Re: Avenal Energy Project (08-AFC-1)

CURE Data Requests, Set One (Nos. 1-59)

The Application for Certification for the AVENAL ENERGY PROJECT

# CALIFORNIA UNIONS FOR RELIABLE ENERGY DATA REQUESTS, SET ONE

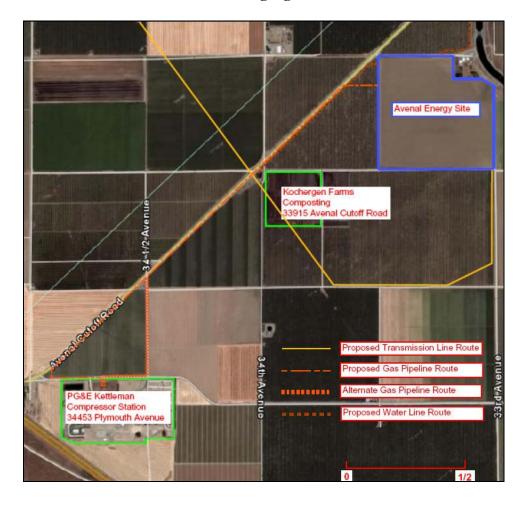
Ground disturbance will result from excavation of natural gas pipeline and water pipeline routes. Additional ground disturbance will result from the construction of foundations for transmission lines.

Approximately 4,000 ft of the pipeline interconnection will occur outside Avenal Cutoff Road and Plymouth Avenue rights-of-way, with an average disturbance corridor of approximately 50 ft;

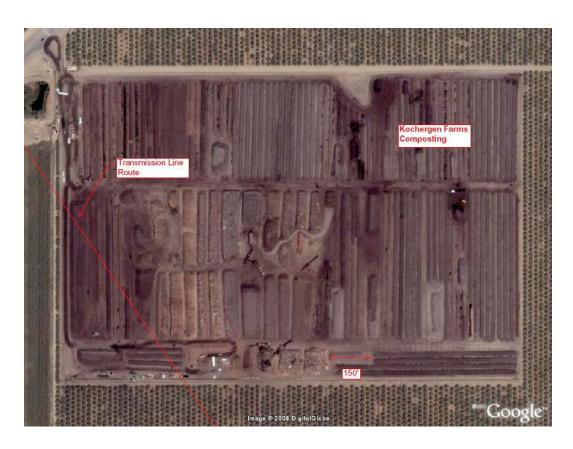
We have mapped the proposed and alternate locations of the pipeline routes and the transmission lines in the following figure:

As shown in the figure, the proposed and alternate natural gas pipeline routes cross the northern extent of the PGE Kettleman Compressor Station and run directly adjacent to Kochergen Farms Composting. The proposed transmission line is routed across the southwestern area of Kochergen Farms Composting as detailed in the figure below.

We have noted that the transmission line towers will have a spacing of approximately 800 feet (AFC, p. 2-49). The distance of the segment of the transmission line that will cross the Kochergen Farms Composting facility is approximately 1000 feet; therefore, at least one tower will need to be constructed within the compost materials as shown in the photograph above.

7 (a) Please describe and map the contaminants at the PGE Kettleman Compressor Station and Kochergen Farms Composting. Please include any soil contaminant data that may indicate a risk to construction workers involved in the excavation or grading of soil at PGE Kettleman Compressor Station and Kochergen Farms Composting for transmission line or pipeline construction.
